## FINAL MITIGATION PLAN

### Bandys Farm Stream and Wetland Mitigation Project Catawba County, North Carolina

Re: NCIRT Review and USACE Approval of the NCDMS Bandys Farm Mitigation Site / Catawba County

**RE: Response to IRT Comments to Final Draft Mitigation Plan  
Bandys Farm Stream and Wetland Mitigation Site  
Catawba River Basin – CU 03050101– Catawba County  
NCDEQ Contract No. 210102-01  
DMS ID No. 100594  
USACE Action ID No. SAW-2021-02609  
NCDEQ DWR ID: 20211630V.1  
RFP No. 16-20210102 (Issued 5/14/2021)**

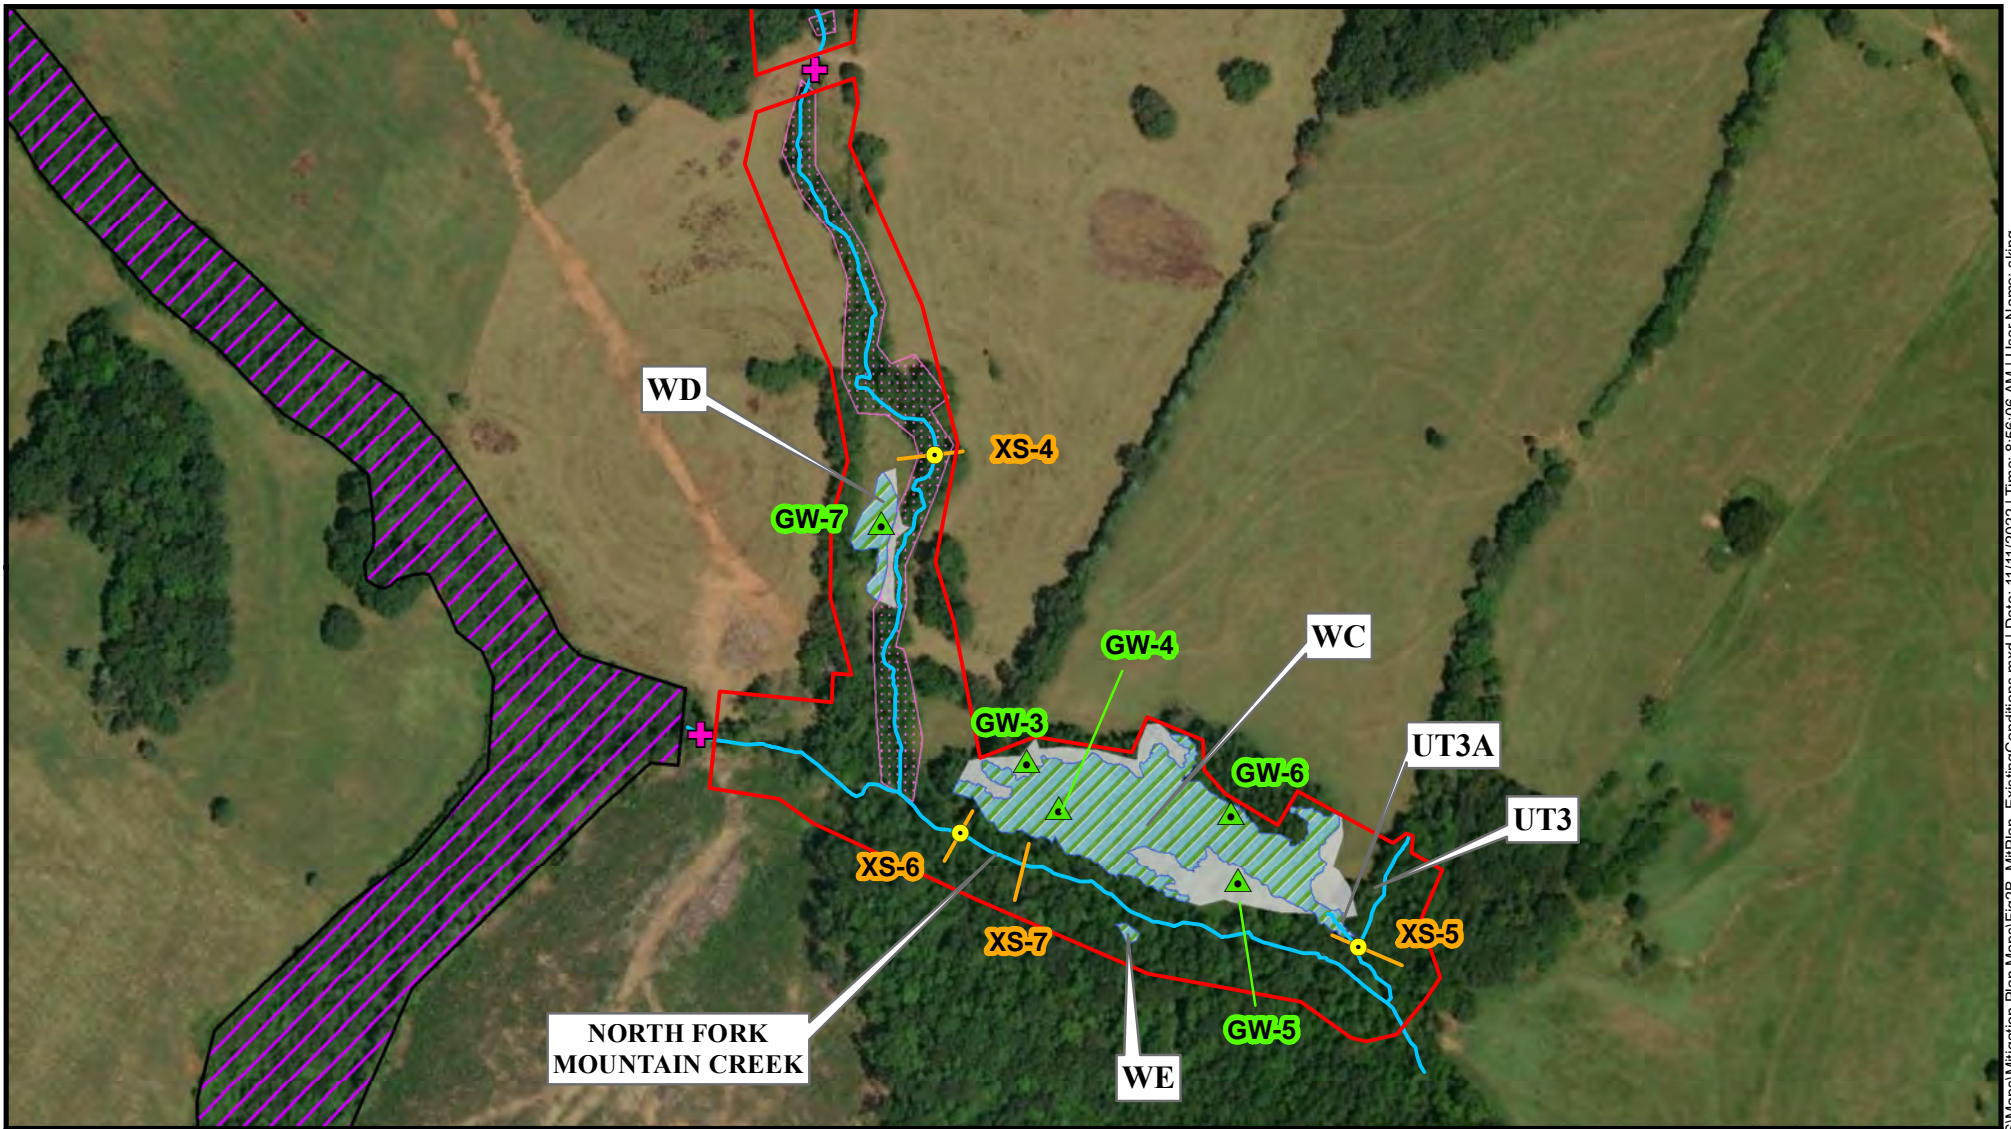
1. Pg. 7 under existing veg: Italicize *Solanum carolinensis*. **Response: Text was corrected.**
2. Figure 2A – there is a band of pink dots (invasive species symbol) across the top 1/4th of the figure. Is this accurate? **Response: That is some type of odd output error from GIS or Adobe. We apologize for not seeing that previously and have corrected that figure in this final version of the report. It is most certainly *not* meant to represent invasive species, just an unfortunate coincidence in similarity.**

<p><b>BANDYS FARM</b>  <b>STREAM AND WETLAND MITIGATION PROJECT</b>                  EXISTING CONDITIONS MAP                  CATAWBA COUNTY, NC</p>		
PREPARED BY:  ECOSYSTEM PLANNING & RESTORATION	  1:4,000	<p>FIGURE 2B</p> <hr/> <p>DATE: NOVEMBER 2022</p>

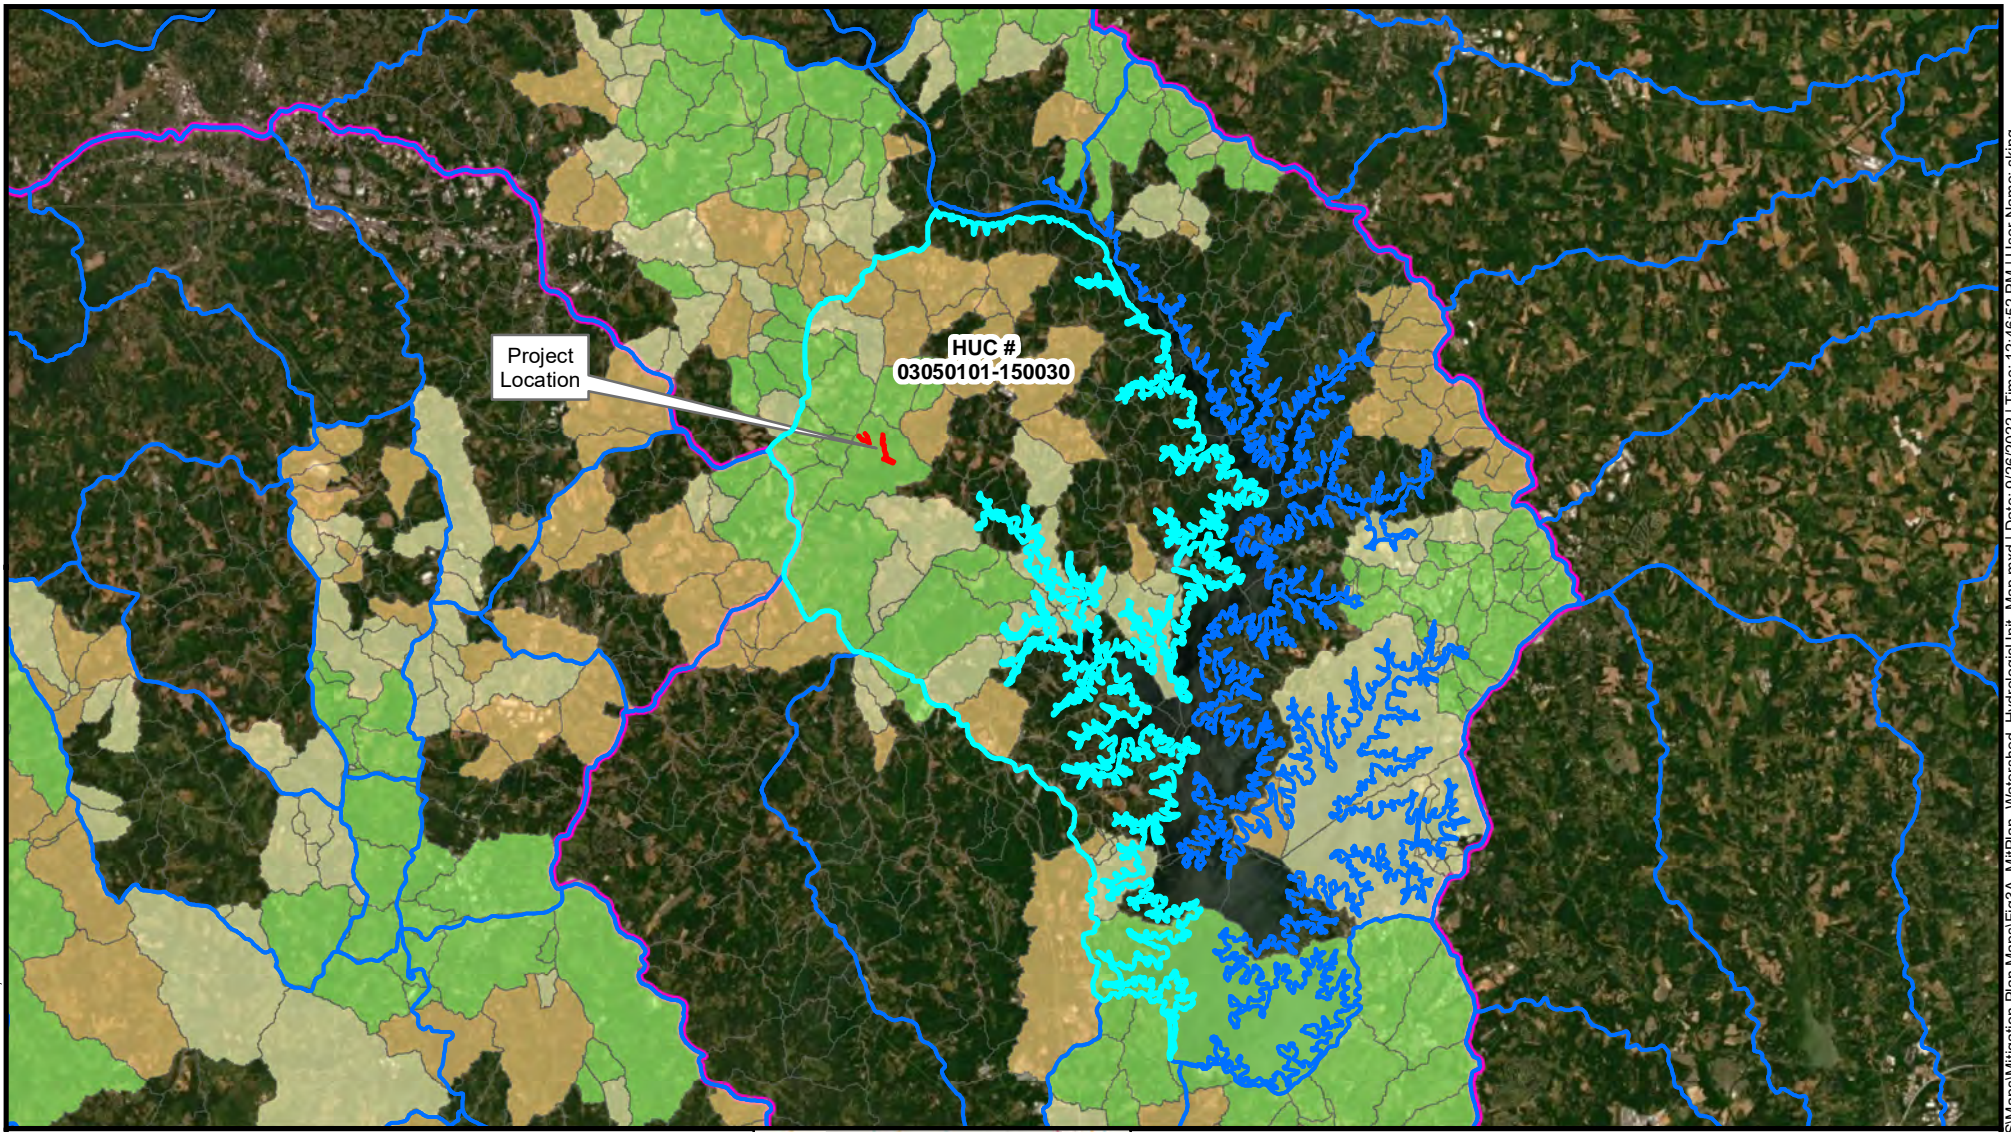
8. Figure 2B- In the existing conditions map, is UT3A a wetland or a stream? **Response: UT3A is a small stream running through wetland area W-C as confirmed in the field by Corps staff during the PJD process.**

<b>BANDYS FARM</b> <b>STREAM AND WETLAND MITIGATION PROJECT</b> <b>PROPOSED MONITORING FEATURES</b> <b>CATAWBA COUNTY, NC</b>		
PREPARED BY: ECOSYSTEM PLANNING & RESTORATION	 1:4,500	FIGURE 10A  DATE: JUNE 2023

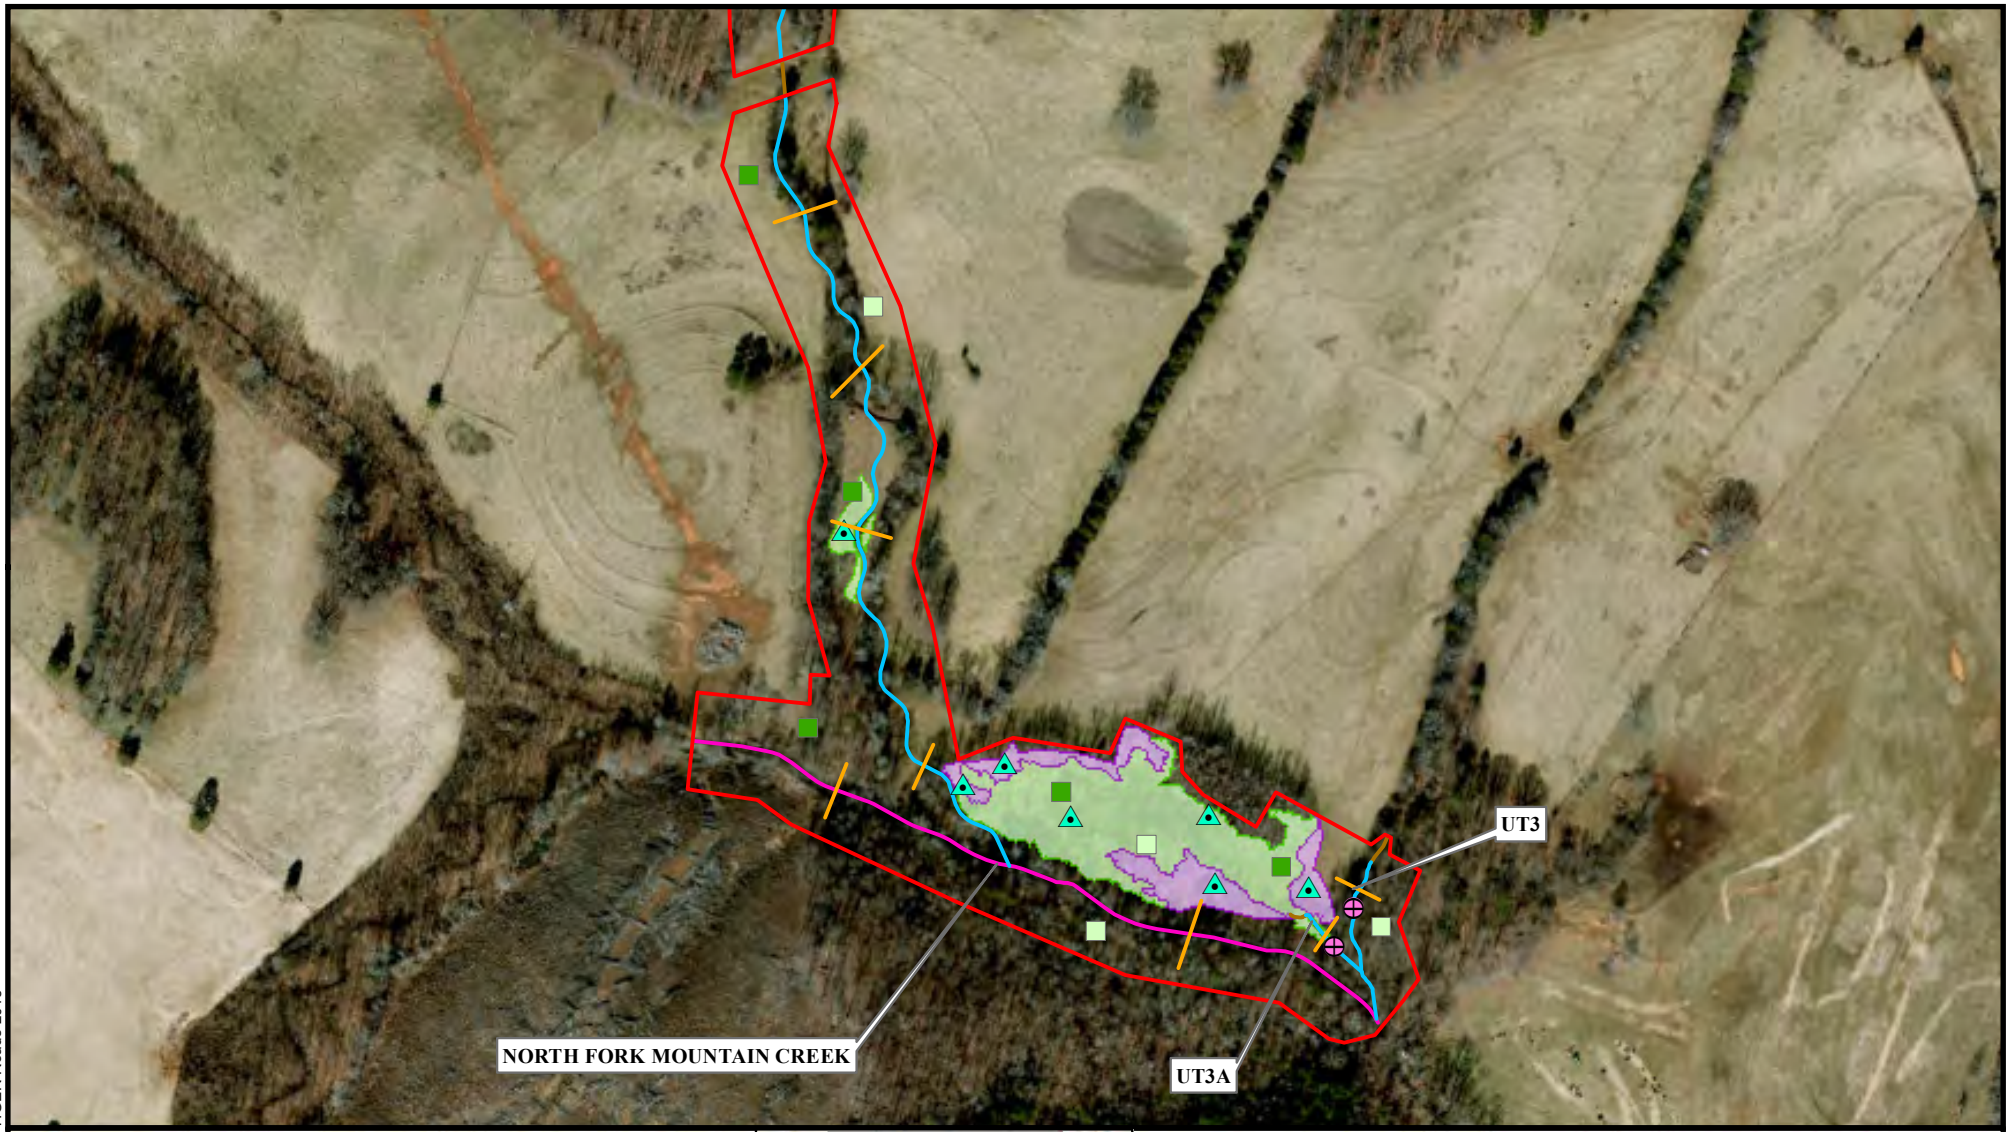
5. Figure 10A – Please swap the veg plot type for the two plots along the UT2 wetland area (i.e., temp to fixed and fixed to temp) so there is a permanent representative veg monitoring station for the W1 credit area. Also, please make sure to capture representative areas of priority 2 bench cuts and valley slopes in veg plot data, as these conditions can be challenging for vegetation establishment. **Response: The veg plot types in that wetland area along UT2 have been swapped as requested. EPR will ensure that areas such as bench cuts will be represented during vegetation plot establishment.**
